UNITED STATES
NUCLEAR REGULATORY COMMISSION
WASHINGTON, D.C. 20555-0001

SUBJECT: ACCOLADE FOR DR. GERRY L. STIREWALT, MANDEX'S TECHNICAL LEAD/SUPERVISOR IN CRADAL, FOR WORK PERFORMED IN SUPPORT OF THE NATIONAL PROGRAM FOR DISPOSAL OF HIGH-LEVEL RADIOACTIVE WASTE IN 1998

APPENDIX F

REVIEW OF U.S. DEPARTMENT OF ENERGY'S GEOLOGIC FRAMEWORK MODEL, VERSION 3.0 (GMF3.0)

Figure 3 - Tramuv model-well miss-tie analysis plot illustrating the difference between the computed horizon and the picked well-log elevations using color coded contours

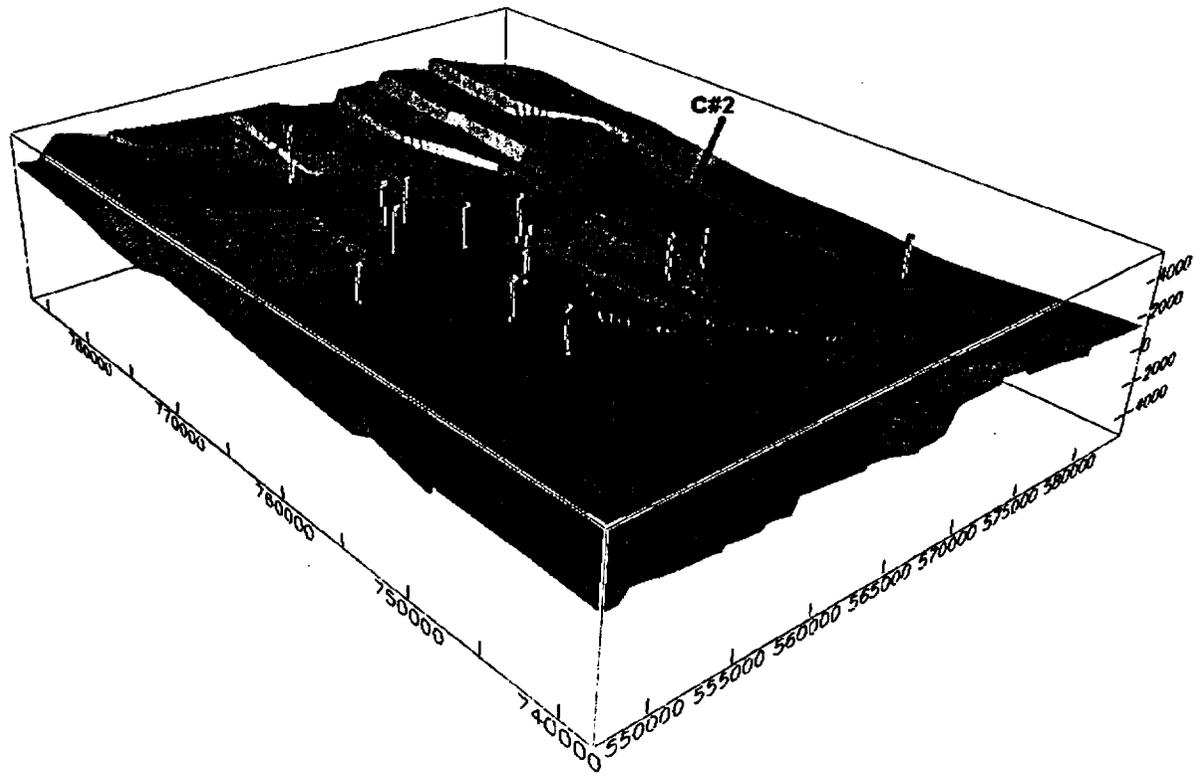
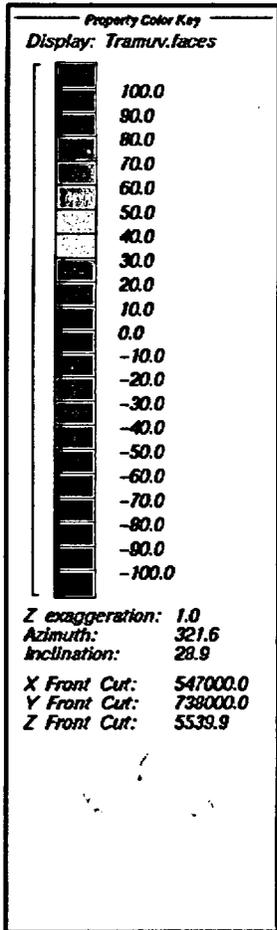
Figure 3 contains a 3-D view of the upper vitrified Tram unit with the model-well discrepancies plotted as color-filled contours. The legend on the left side of the plot defines the miss-tie range as plus/minus 100 feet. The gray boxes above the model surface represent the locations of the well log data that were used as control points for computing the horizon elevations. The red circular region in the vicinity of the C#2 well represents a model-well mismatch of -53 feet. This means the EarthVision software computed the elevation of the horizon to be 53 feet higher than the geologist picked the horizon location on the C#2 well logs. Only 14 well control points were available for the computation of this Tram unit, and Figure 3 illustrates that the C#2 well is not surrounded by wells having smaller model-well miss-ties. Thus, one cannot confidently say that the C#2 well log pick is bad and has been disregarded by the EarthVision software as an outlier. A case could be made that: (1) the -53 foot C#2 discrepancy is the result of insufficient data to constrain the EarthVision software; or (2) that the fault structure in the GFM3.0 model has resulted in the C#2 well being located on the wrong side of a fault. Figure 3 shows the C#2 well in very close proximity to the Midway fault, which may possibly be explained by an incorrect assumption that: (1) the C#2 well is not deviated; or (2) that the subsurface control on the Midway fault is incorrect.

Figure 4 - Calico model-well miss-tie analysis plot illustrating the difference between the computed horizon and the picked well-log elevations using color coded contours

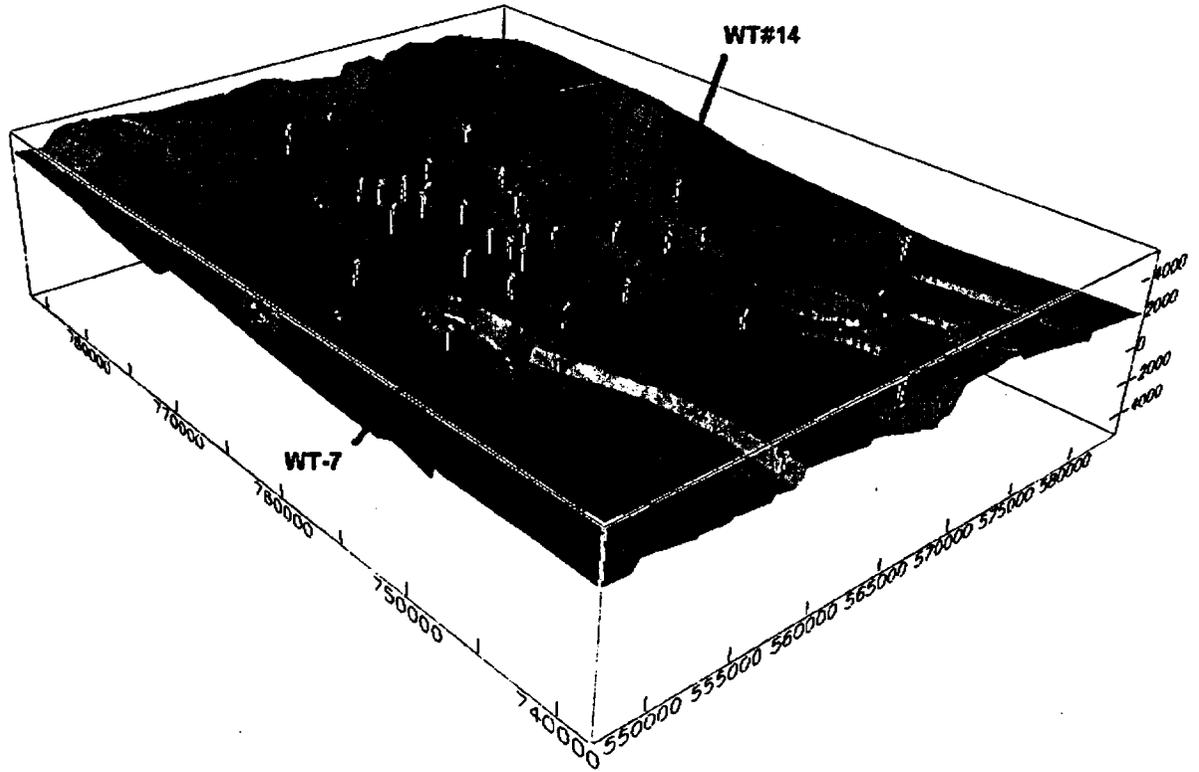
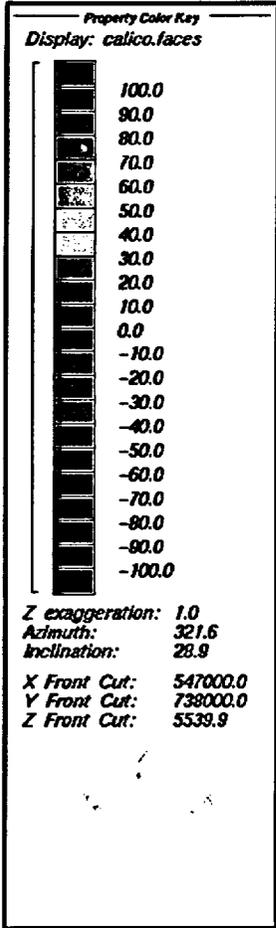
Figure 4 shows discrepancies of +117 and -56 feet where the WT-7 and WT#14 wells intersect the Calico horizon near the SolWest and Paintbrush faults, respectively. Figure 5 also shows +59 and -88 foot discrepancies for the WT-7 and WT#14 wells intersecting the Tptpl unit. Again, it may be possible to ascribe the discrepancies to incorrect borehole placement or inaccurate subsurface fault control. However, the -117 foot discrepancy for the WT#6 well in Figure 5 is not as easily explained because a fault surface is not present in the vicinity of the borehole. This disagreement may possibly be explained as a data outlier, poorly constrained software calculations, or the presence of an unmapped fault.

Figure 5 - Tptpll model-well miss-tie analysis plot illustrating the difference between the computed horizon and the picked well-log elevations using color coded contours

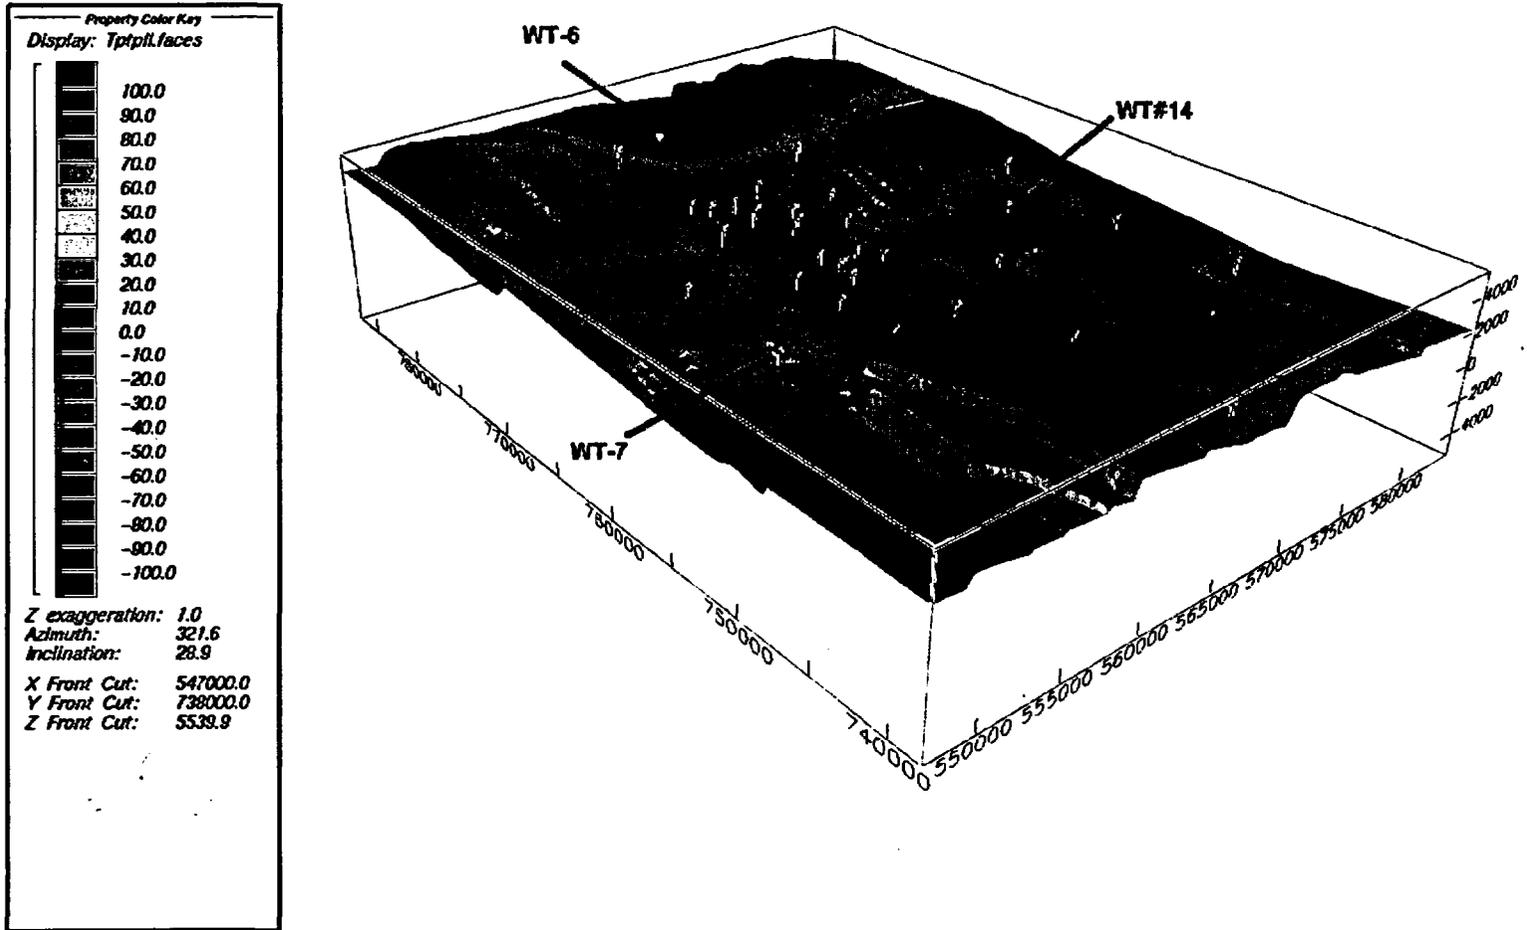
minimal and may reflect sparse data. Effects of sparse data may also be reflected in GFM3.0 as greater discrepancies between the data and the extrapolations made by EarthVision software for depths to stratigraphic horizons (See Figure 5 in Part I). Consider clarifying what uncertainties are associated with the estimates to the depth of the Paleozoic surface.

Figure 5. Planar fault ironw3 (tan) as originally included in GFM3.0. Also shown are part of the Solitario Canyon fault (green) and Splay S

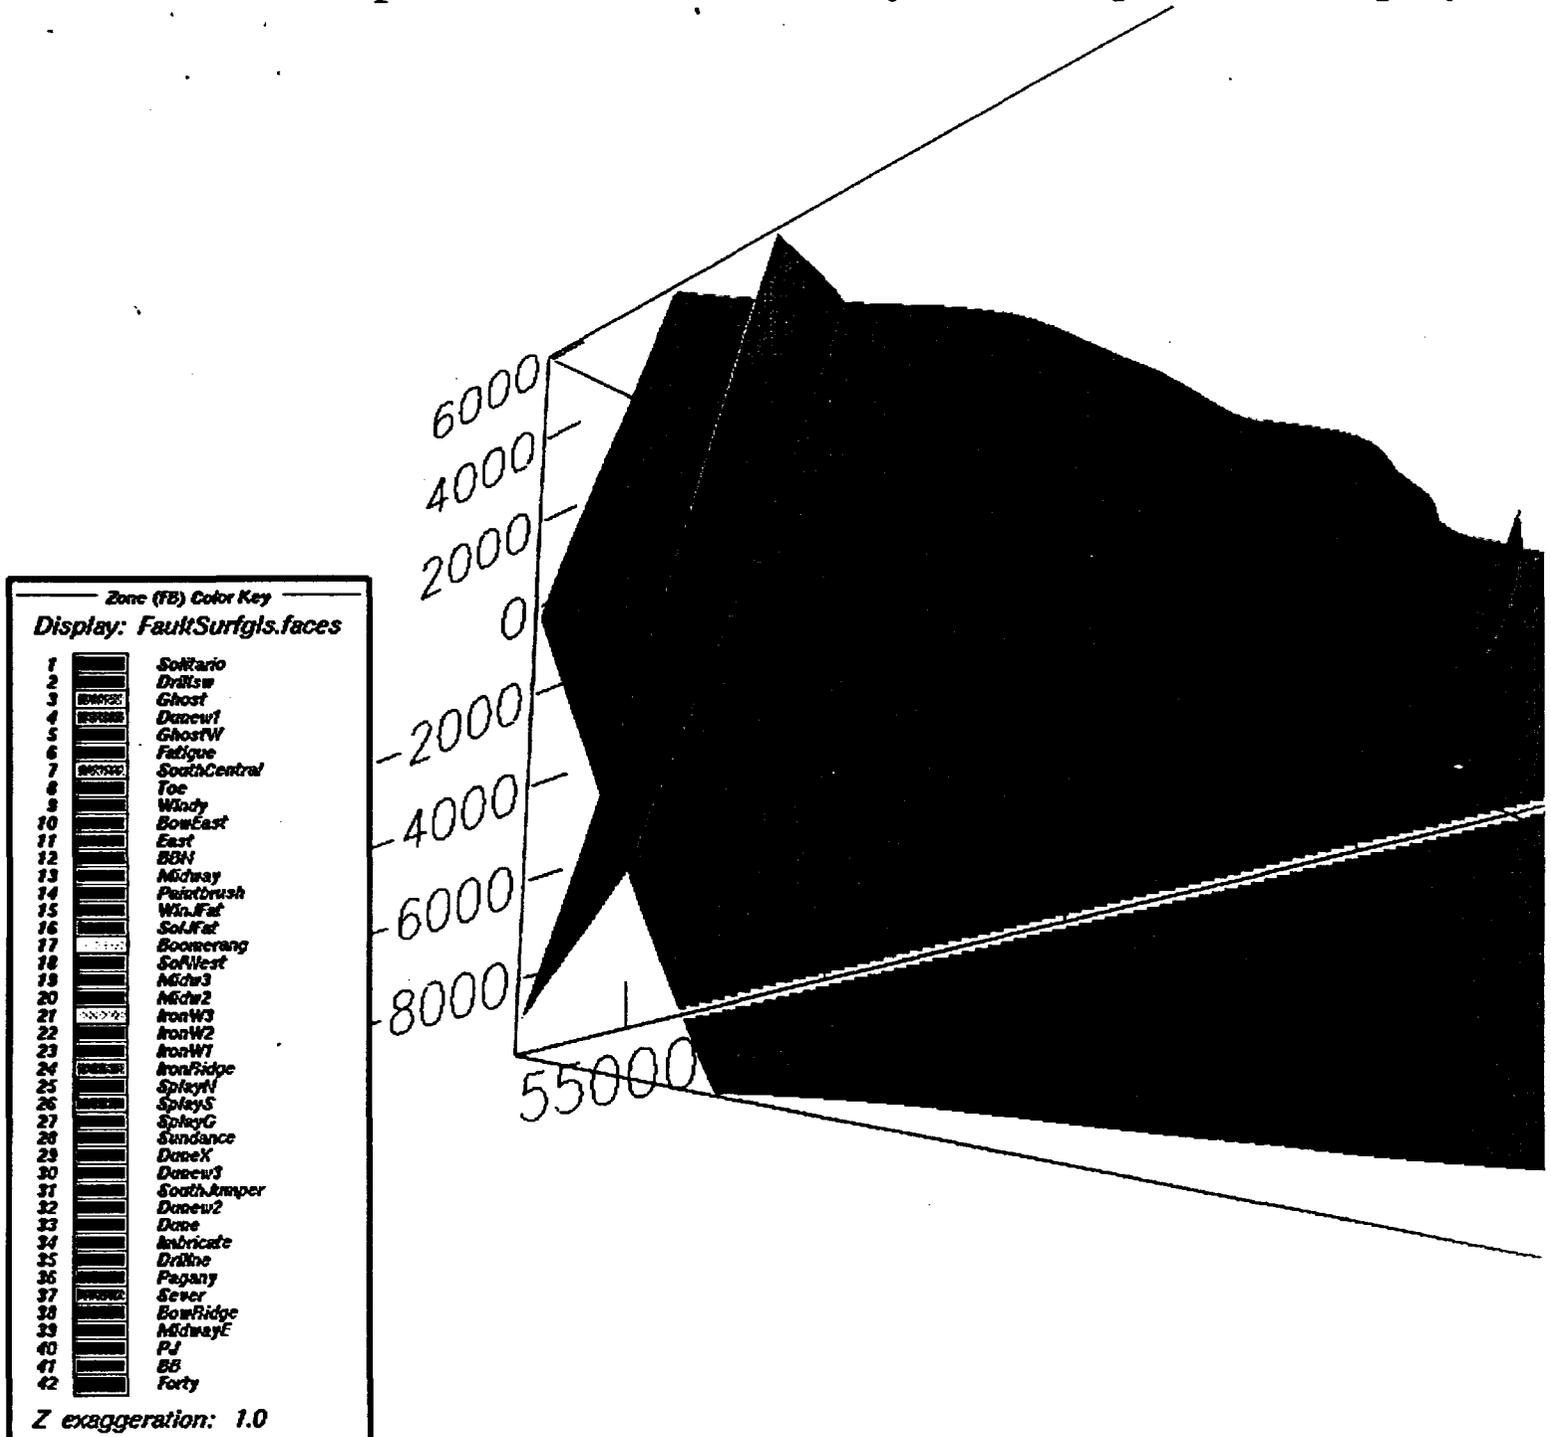
Faults Ironw1, Ironw2, and Ironw3, located in the southwestern corner of GFM3.0, were represented in the model as planar structures extending to the base of the model at -8000 feet. The subsurface geometry of fault Ironw3 in the "Ironw" system was successfully modified to generate a non-planar fault that terminated at a depth no greater than -2000 feet against the Solitario Canyon fault. This test illustrates that it is practicable to alter subsurface geometry of faults in GFM3.0 for incorporating alternative interpretations of fault geometry. Figure 5 illustrates the planar subsurface geometry of Ironw3 as originally represented in GFM3.0 along with non-planar fault Splay S. Figure 6 shows Ironw3 as modified for this test to terminate against the Solitario Canyon fault at a depth no greater than -2000 feet. Fault Splay S is included in the figure to show the similarity between the geometry of Splay S and modified Ironw3.

Figure 6. Fault Ironw (tan) modified to intersect the Solitario Canyon fault (green) no deeper than -2000 feet. Original Splay S is also shown

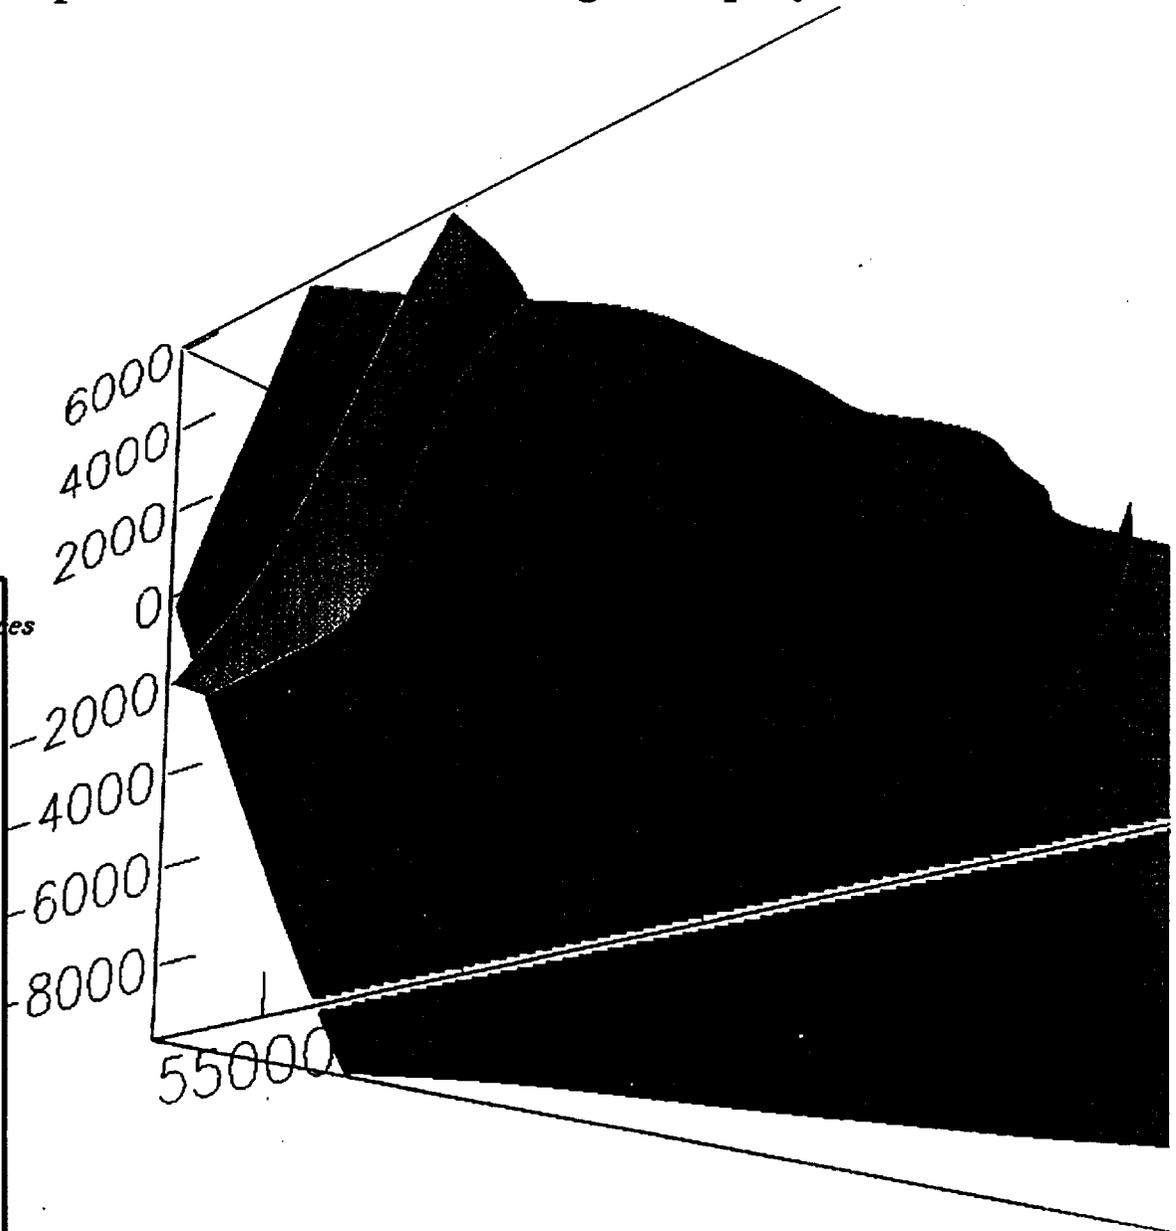
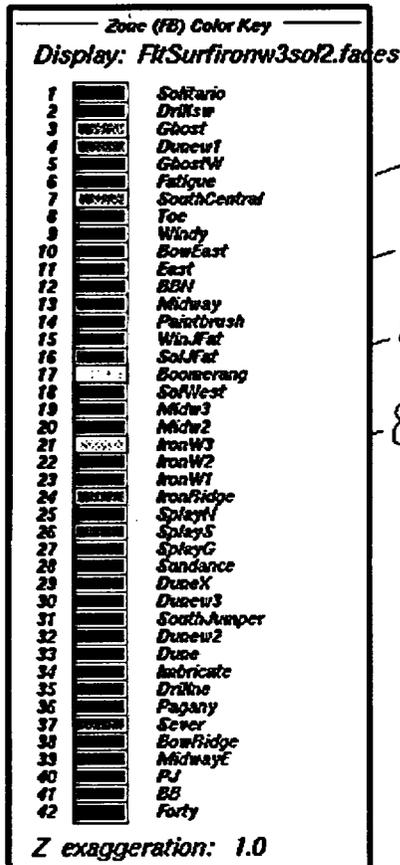
In summary, the result of this successful test illustrated by Figure 6 proves it is possible to modify GFM3.0 and incorporate alternative interpretations of subsurface fault geometry into the model. Although a detailed explanation of the steps necessary to generate modified fault surfaces is beyond the scope of this letter report, some words of caution are advised. When fault geometries are changed, before running the master sequence (.seq) file in GSB to generate modified .faces files for structure models, it may be necessary to rebuild the fault tree or re-grid horizons in the fault blocks. In particular, if the number of fault blocks is either reduced or increased, as is likely when removing an existing fault or adding a new one in the model, rebuilding the fault tree and re-gridding of horizons in the altered fault blocks are commonly necessary before the .seq file can be used in GSB to calculate .faces files for the suite of structure models (i.e., fault surfaces and blocks and zone surfaces and blocks).

Figure 8 – Cross section 1. This section illustrates folding in the hangingwall of the PCF without curvature in the associated fault plane. Slight curvature of the FMWF may not be sufficient to produce tilting as shown in the hangingwall. See Figure 7 for location.

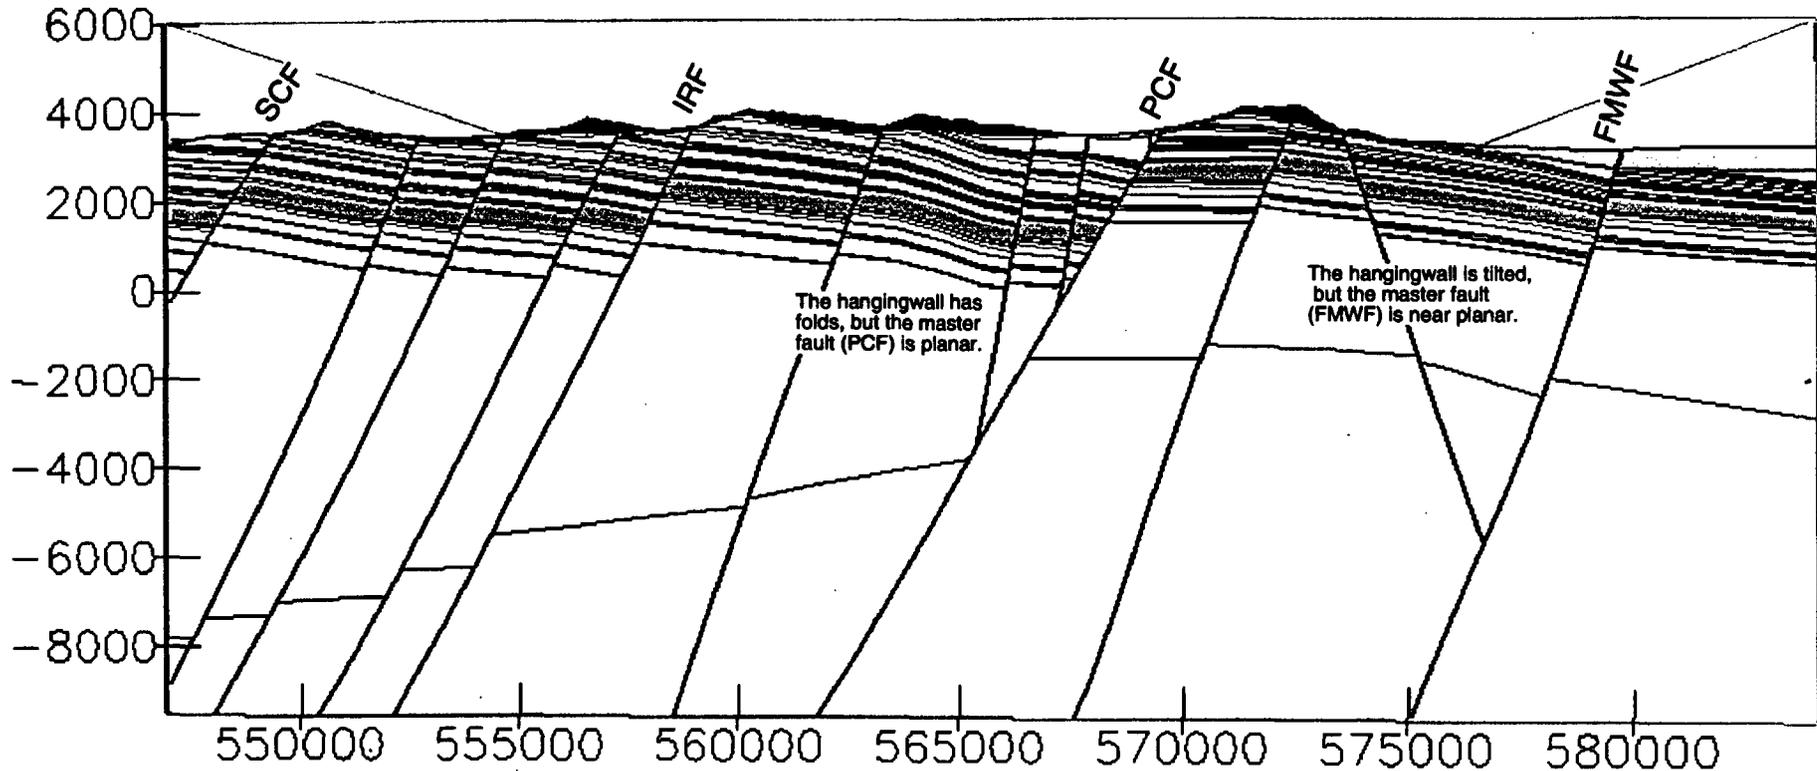
- d. Folding developed in the hangingwall blocks of faults is generally attributed to a curved (i.e., listric) fault geometry at depth (Suppe, 1983; Dula, 1992). Sections 1 (Figure 8) and 8 (Figure 15) through the model appear to illustrate folding of units in hangingwall blocks although GFM3.0 is constructed with essentially planar faults. Explanation of why these units appear to be folded may be helpful. By some interpretations (e.g., Young, et al., 1992), at the depth to which the model was constructed (i.e., 8,000 feet below sea level), the Forty Mile Wash, Paintbrush Canyon, Midway Valley, and Bow Ridge faults would show curved trajectories.
